UNITED STATES  
DEPARTMENT OF THE INTERIOR  
BUREAU OF LAND MANAGEMENT

FORM APPROVED  
OMB NO. 1004-0137  
Expires: January 31, 2018**SUNDRY NOTICES AND REPORTS ON WELLS CONSERVATION**  
**Do not use this form for proposals to drill or re-enter an abandoned well. Use form 3160-3 (APD) for such proposals.**5. Lease Serial No.  
NMLC054988A

8. Well Name and No.  
BERRY A FEDERAL 59. API Well No.  
30-015-23155-00-S110. Field and Pool or Exploratory Area  
GRAYBURG11. County or Parish, State  
EDDY COUNTY, NM

**Permanent Abandonment of Federal Wells**  
**Conditions of Approval (LPC Habitat)**

Berry A Federal #5 Wellbore diagram

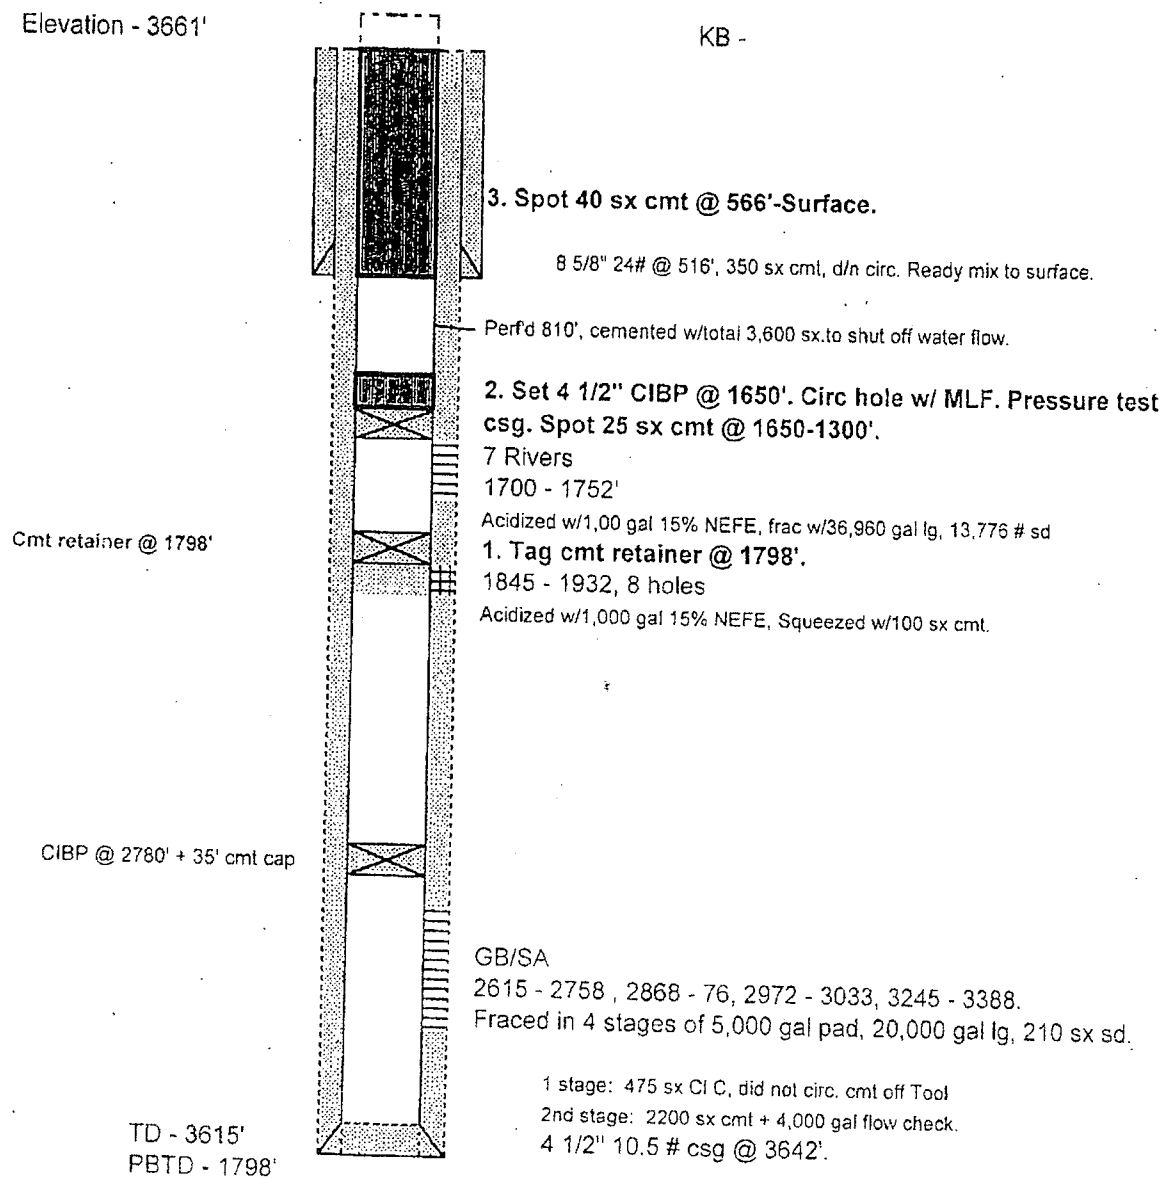
Add Plug From  
1247-1100. 400L  
(Yates, B/salt) TOGC 8/22/19  
Accepted for record - NMOCSEE ATTACHED FOR  
CONDITIONS OF APPROVAL

Below ground level dry hole marker required
